## **ADDENDUM #2**

DATE: September 16, 2016

TO CONTRACT DOCUMENTS ENTITLED: Biotech Connector  
1901 N. 21<sup>st</sup> Street  
Lincoln, Nebraska

**Item 2-4: E1.01- FOURTH FLOOR LIGHTING PLAN**

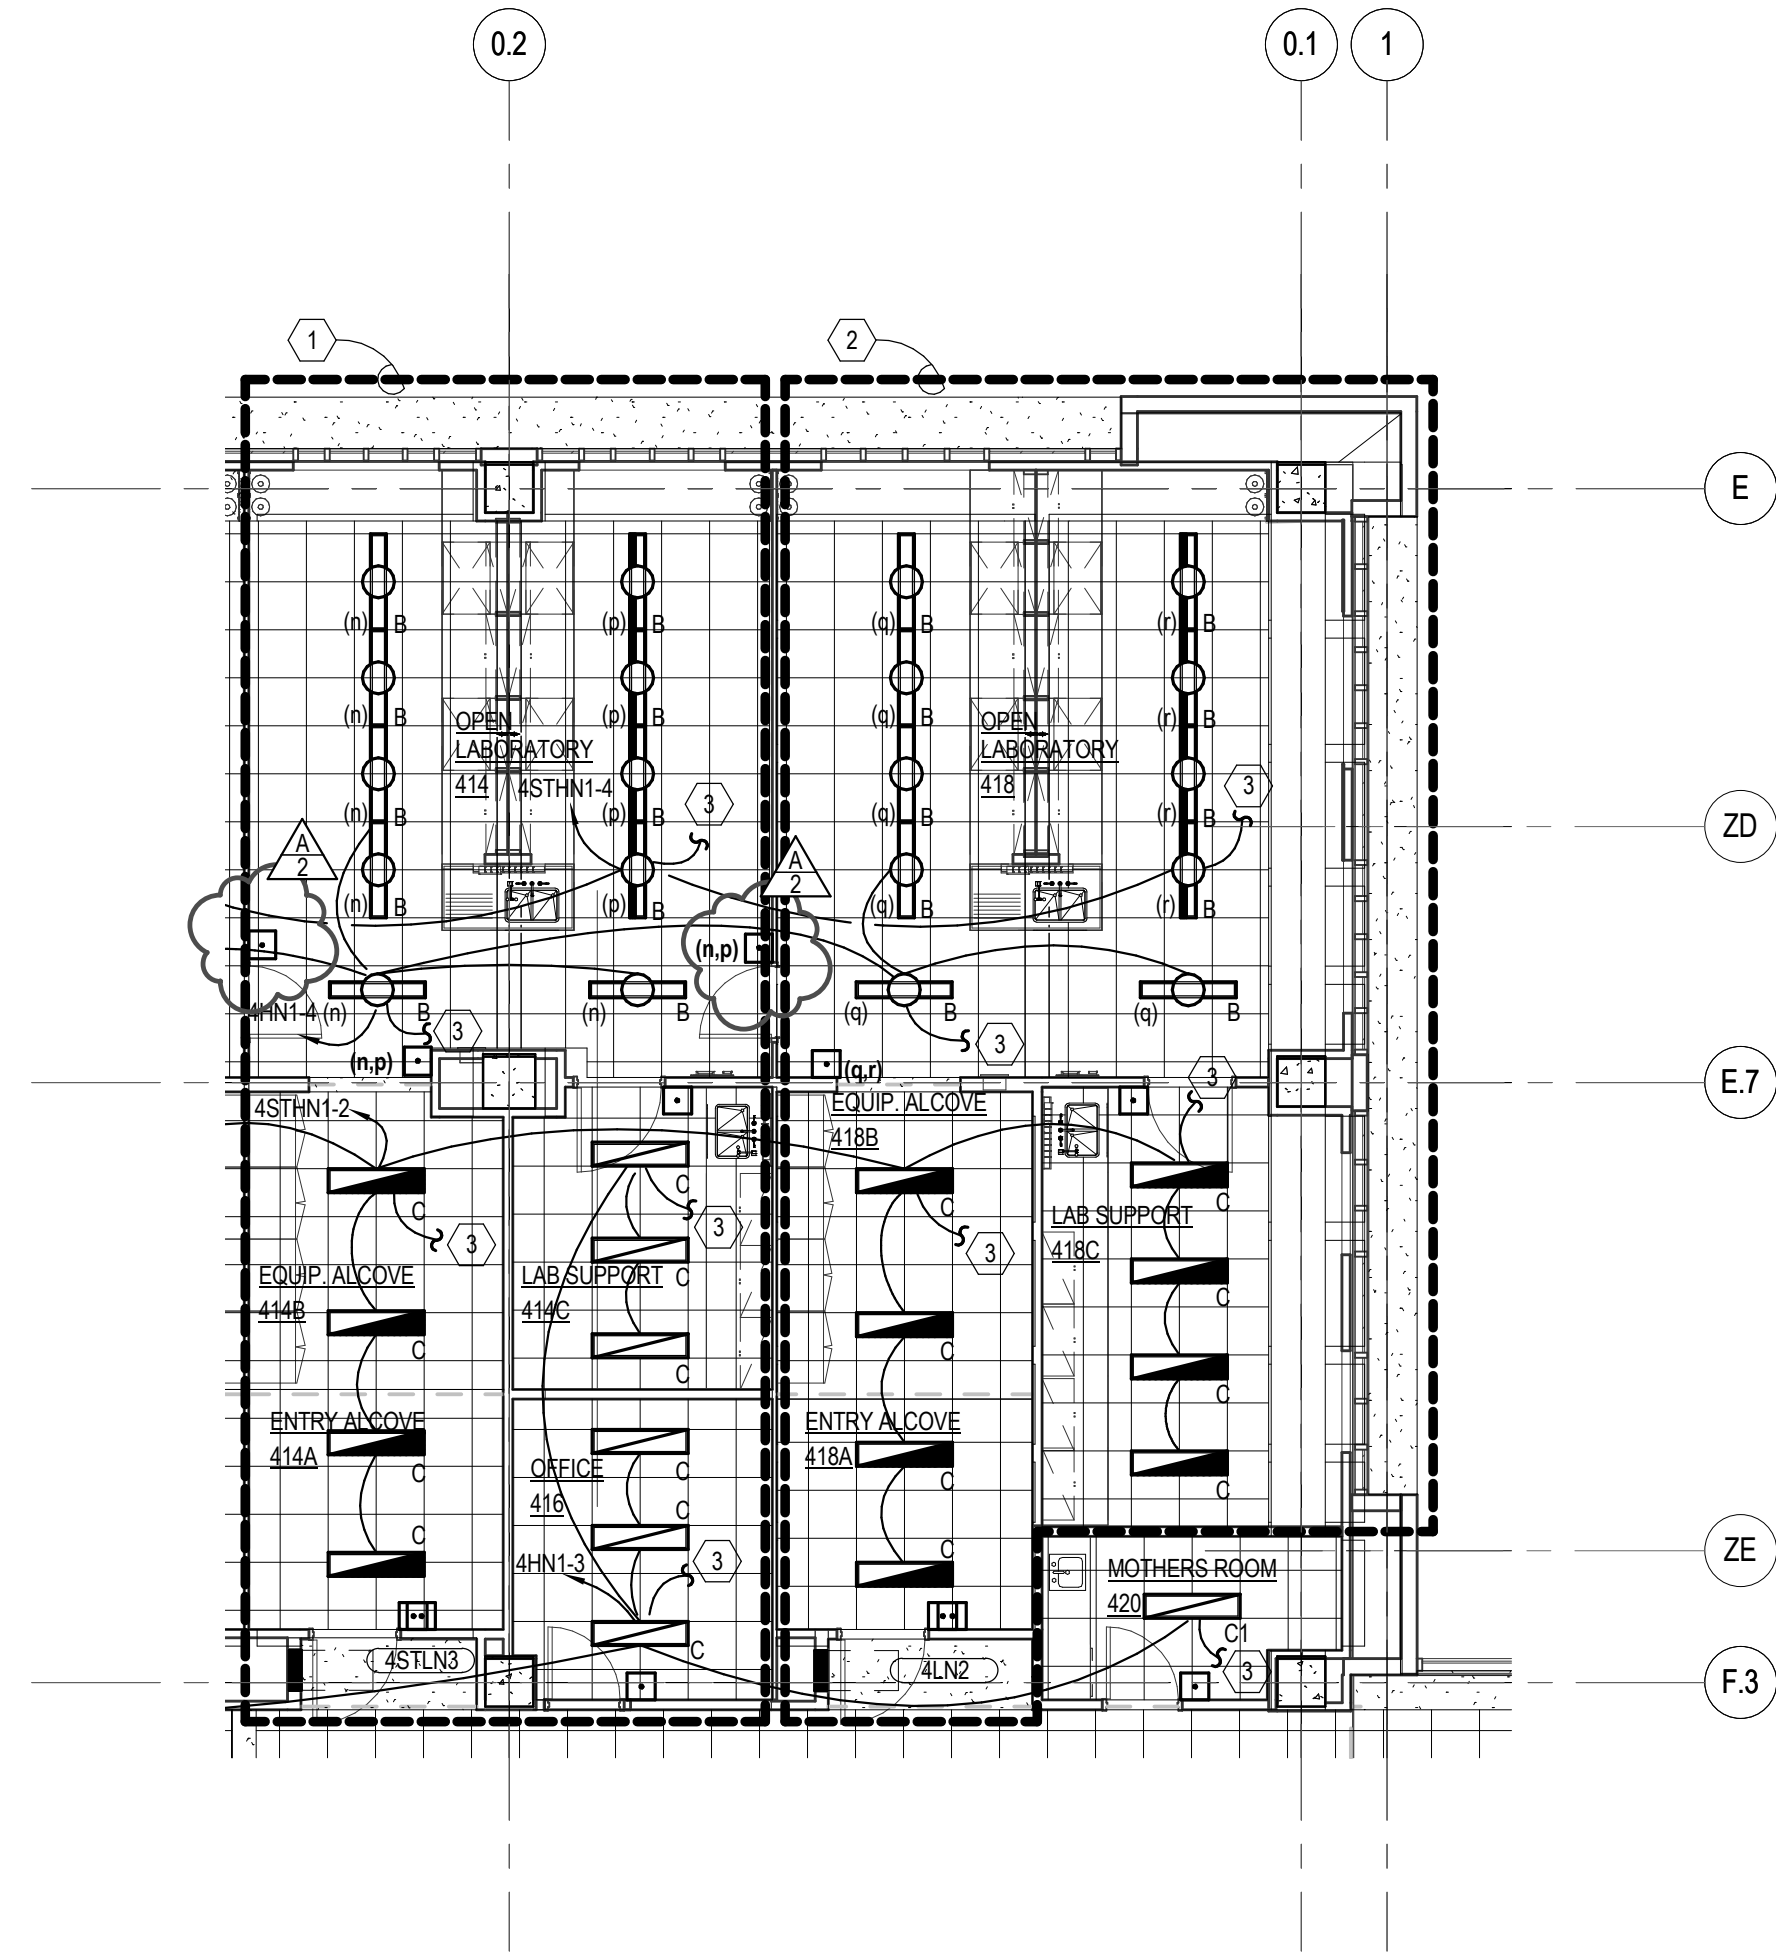
Surface mounted devices have been recessed in demountable walls. See the attached sheet E1.01 for additional information.

IF ALTERNATE #6 IS ACCEPTED, ALL DEVICES SHOWN IN DEMOUNTABLE WALLS SHALL BE RECESSED.

**E1.02**

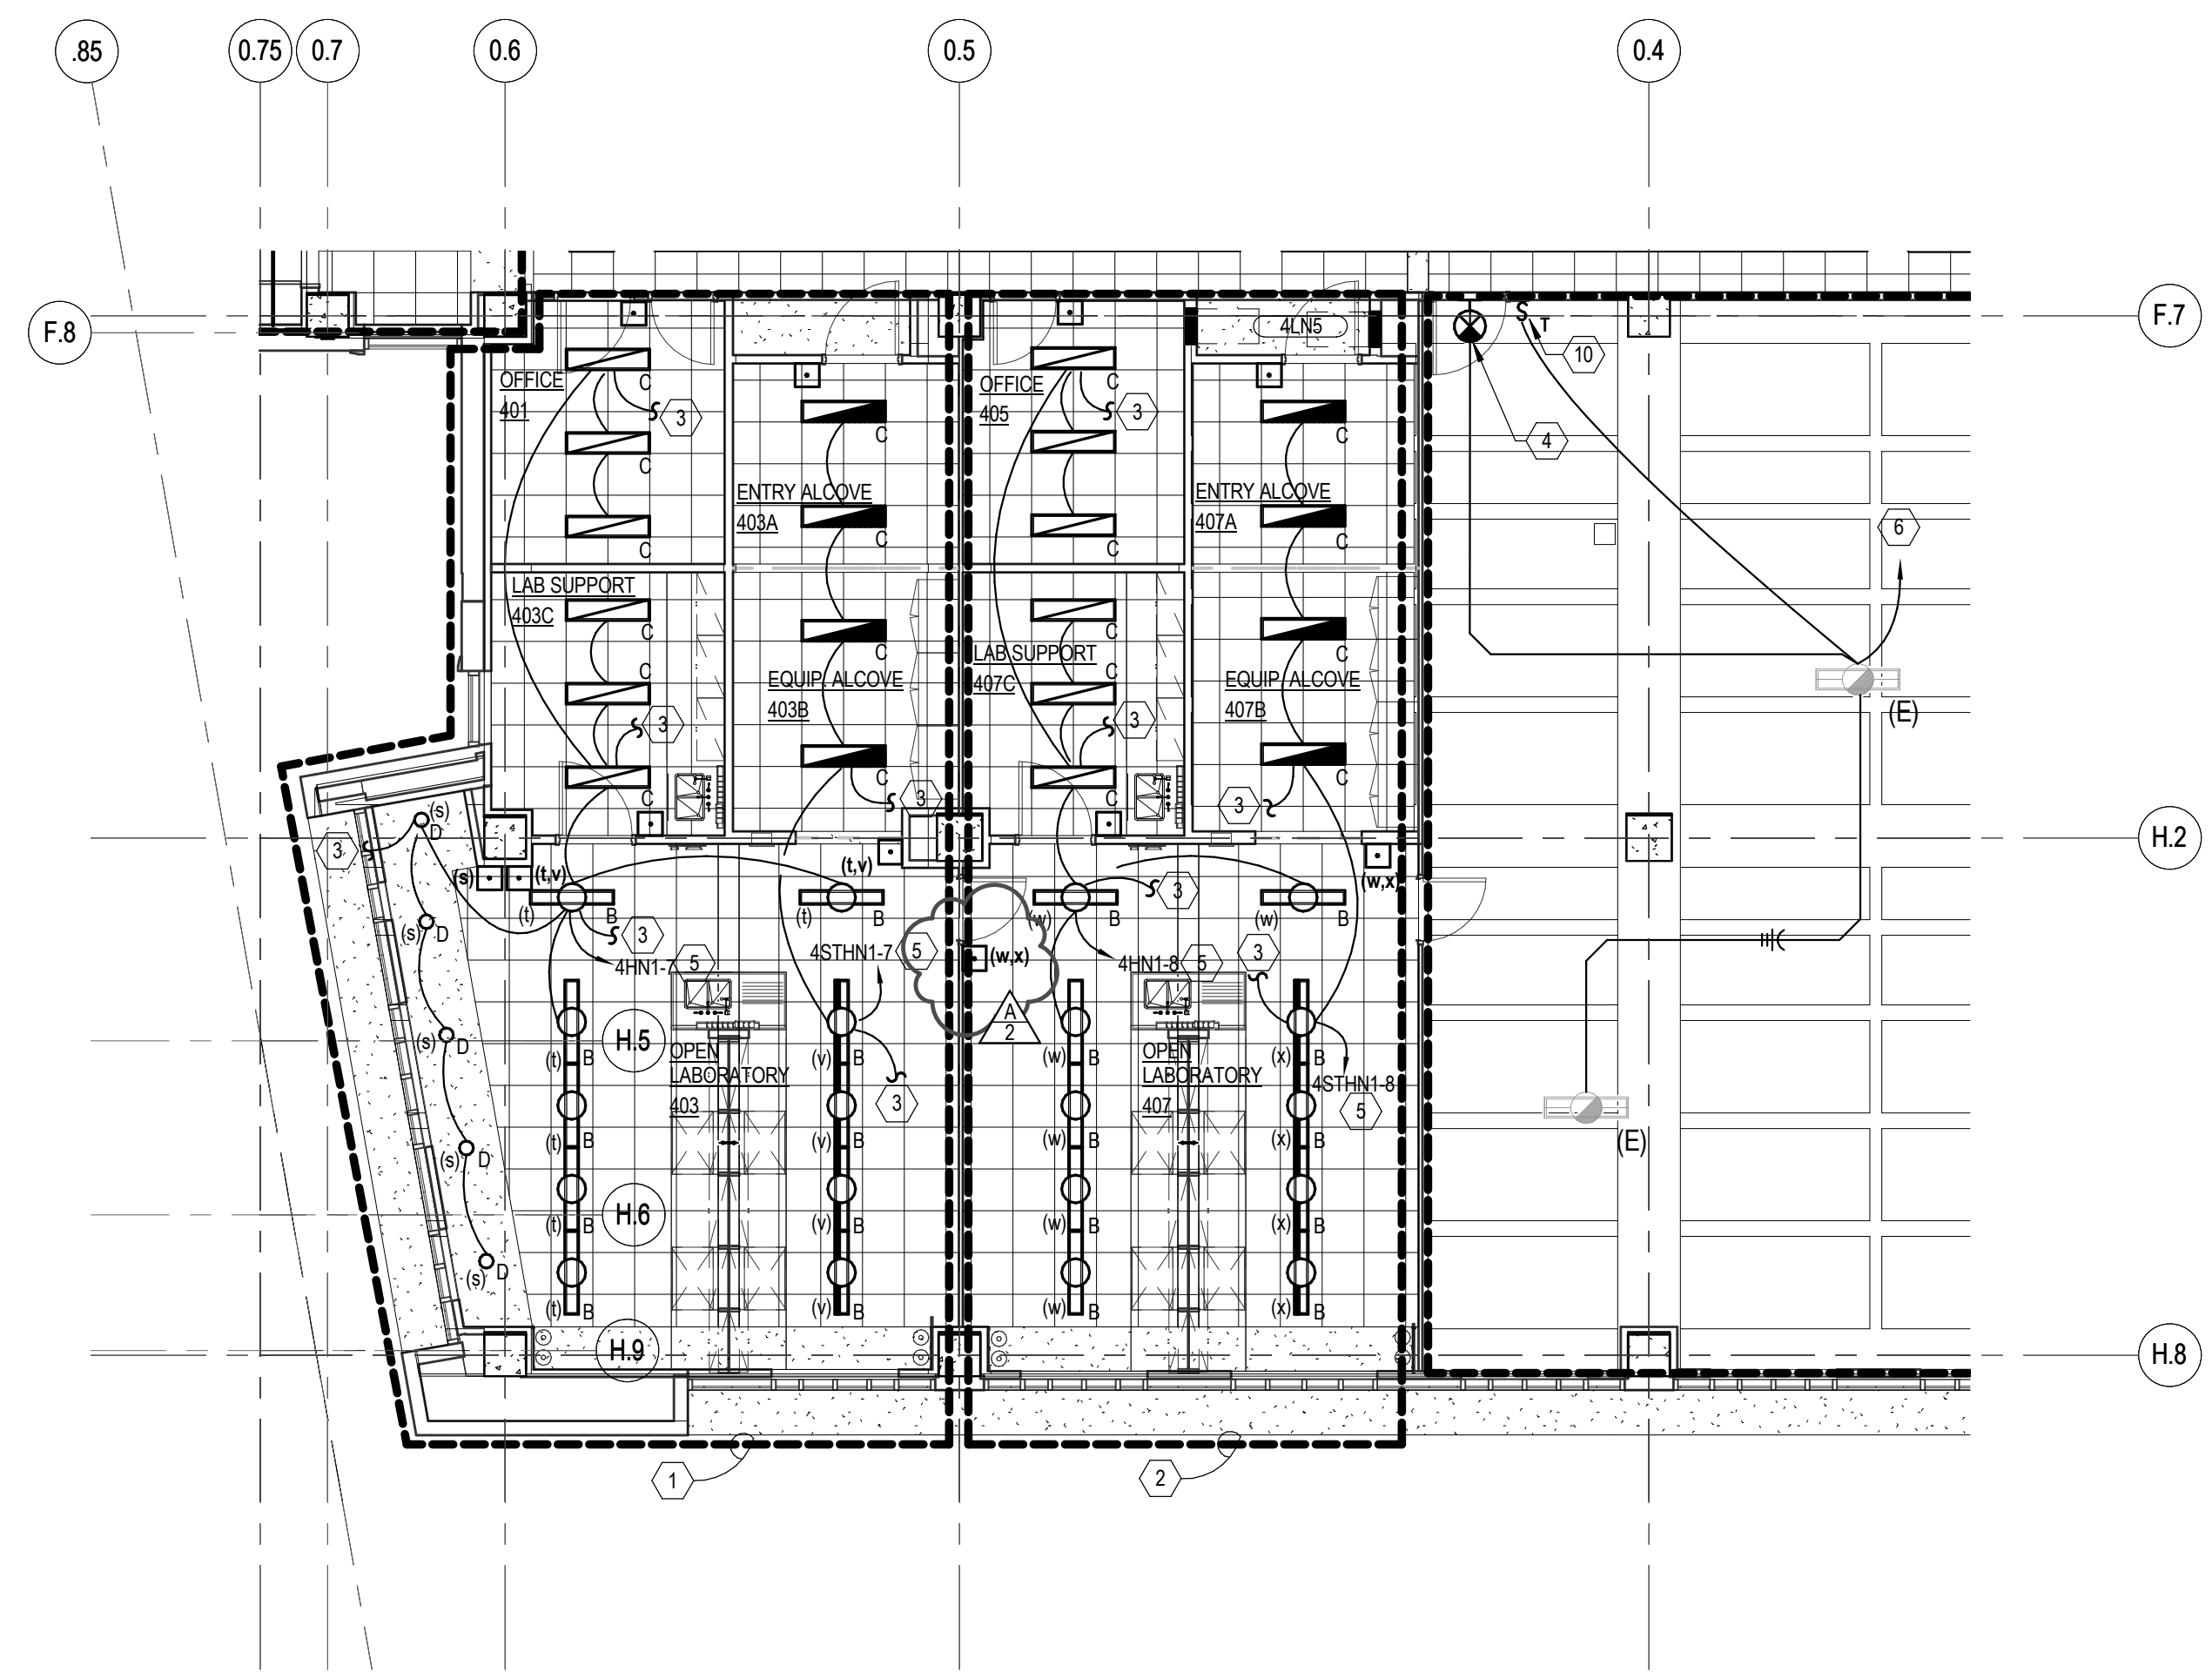
Surface mounted devices have been recessed in demountable walls. See the attached sheet E1.02 for additional information.

IF ALTERNATE #6 IS ACCEPTED, ALL SERVICES SHOWN IN DEMOUNTABLE WALLS SHALL BE RECESSED

**E2.01**

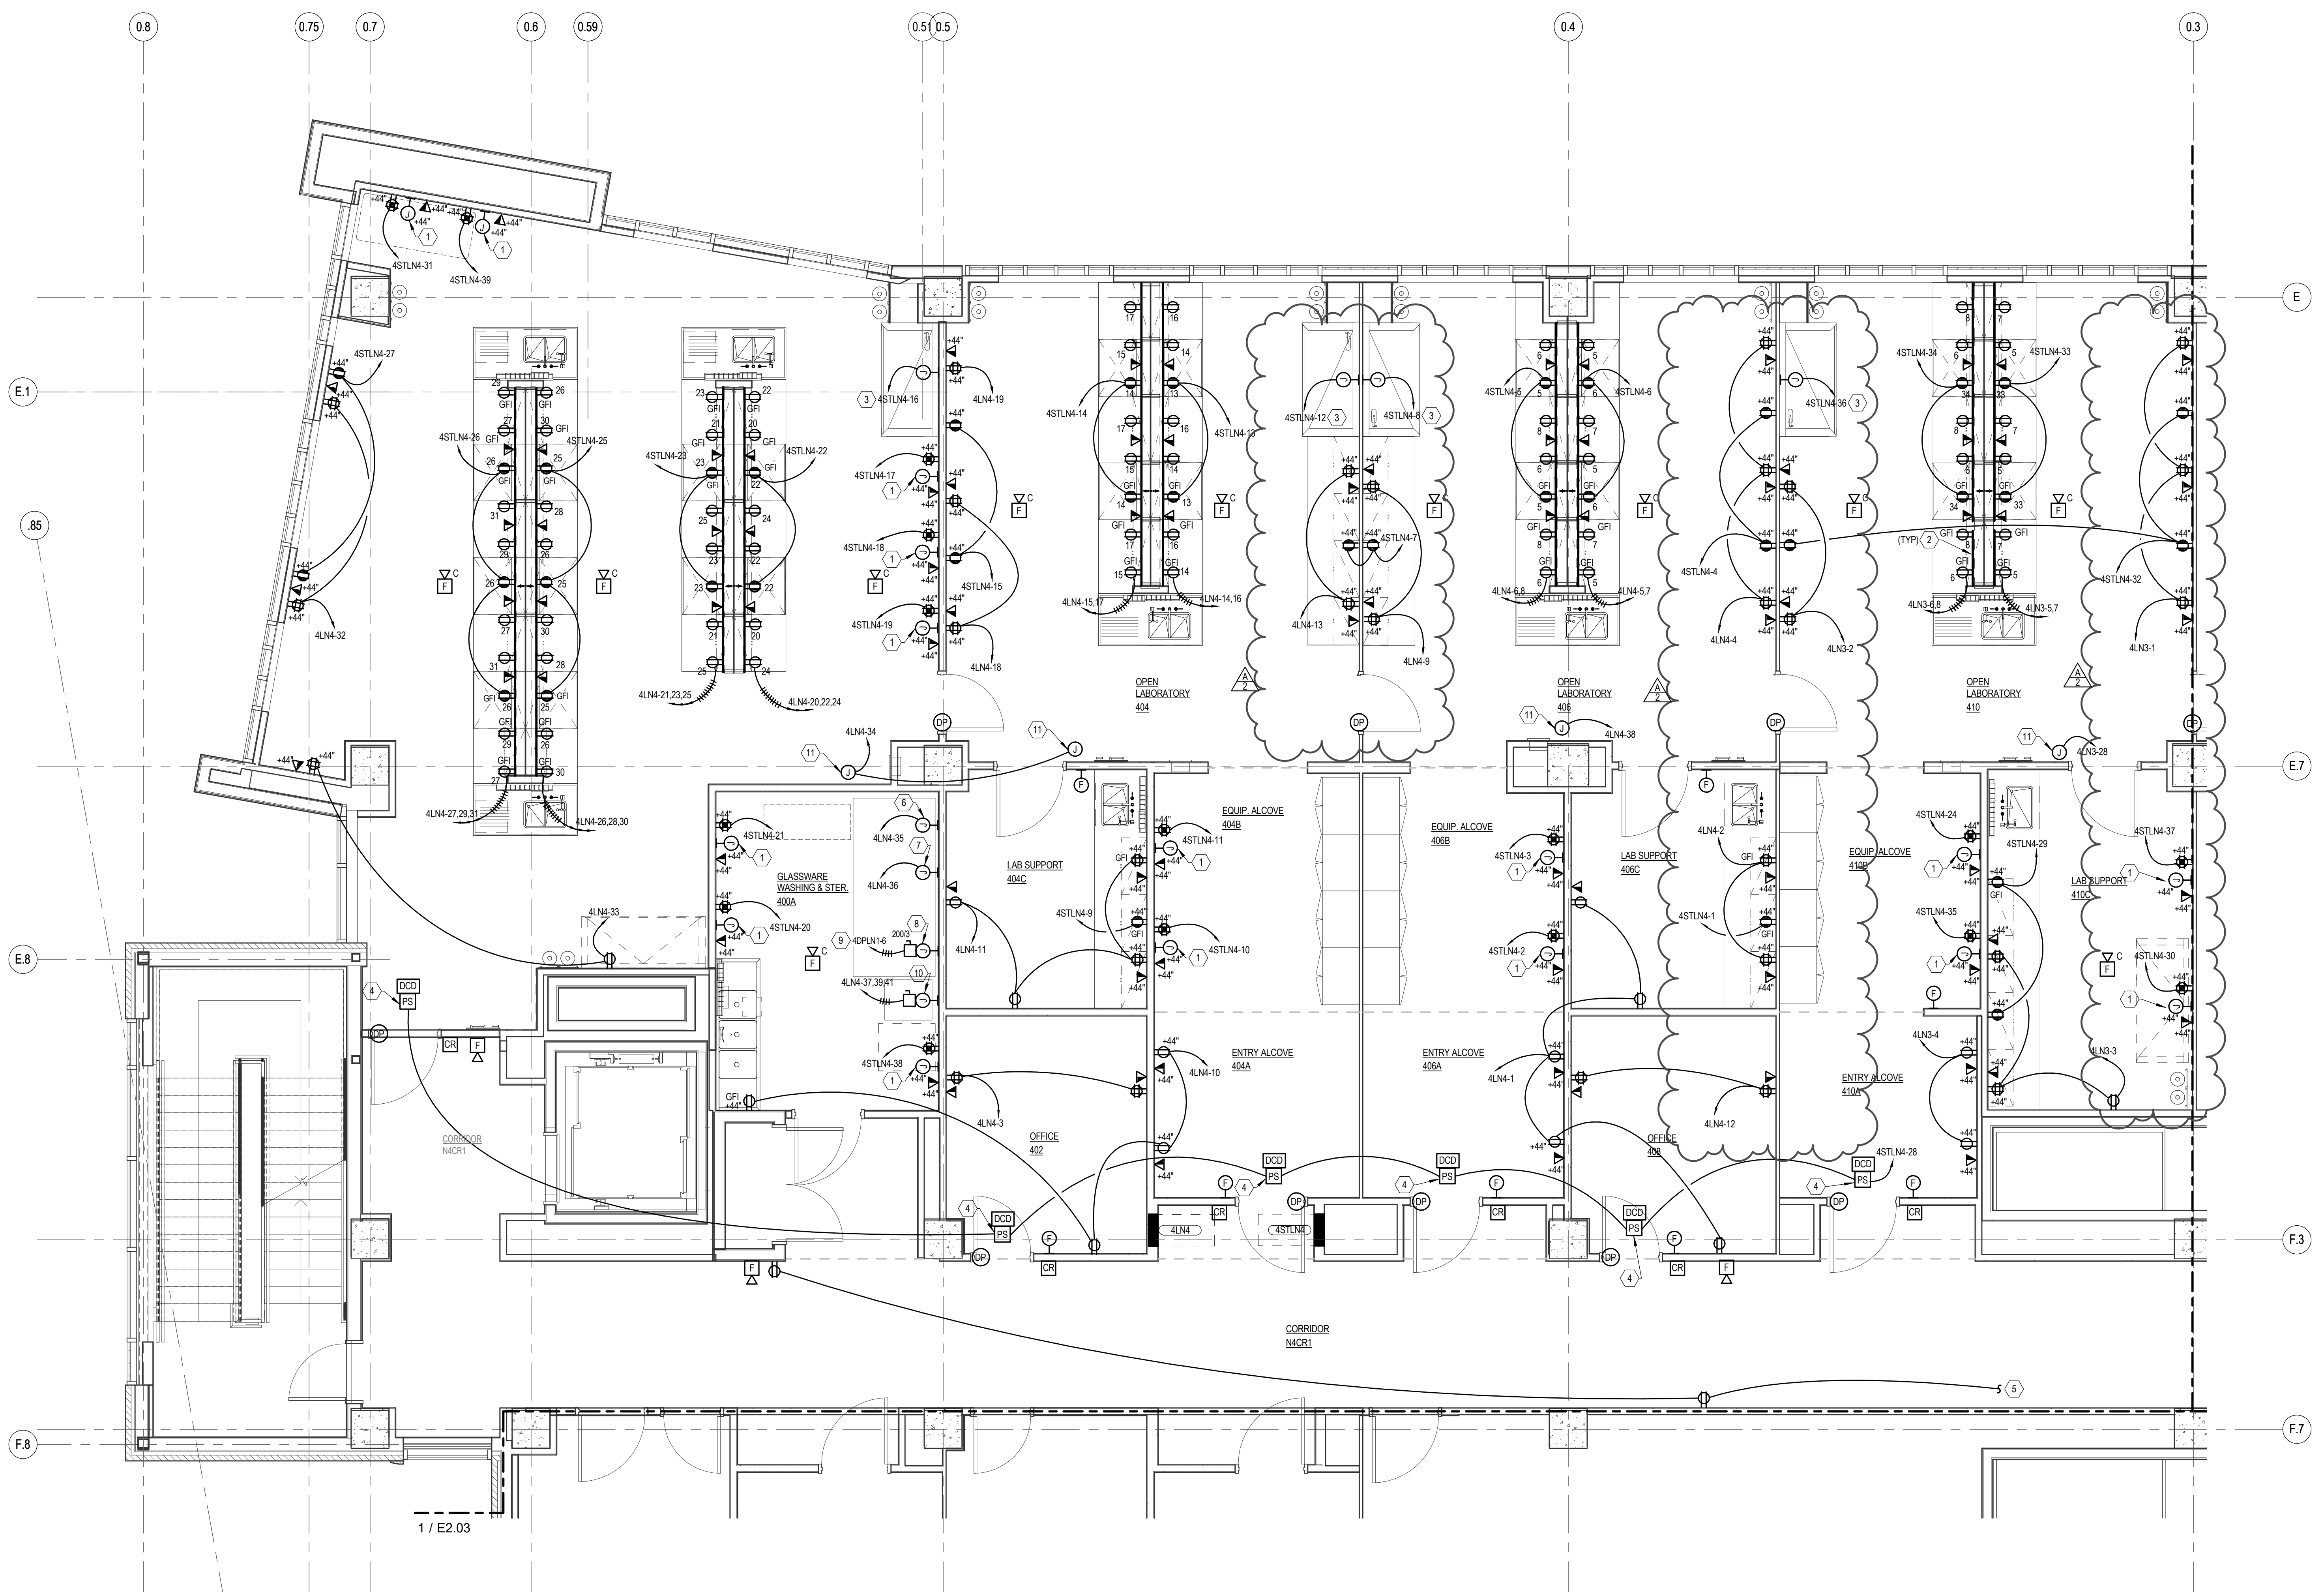
Surface mounted devices have been recessed in demountable walls. See the attached sheet E2.01 for additional information.

IF ALTERNATE #6 IS ACCEPTED, ALL SERVICES SHOWN IN DEMOUNTABLE WALLS SHALL BE RECESSED.
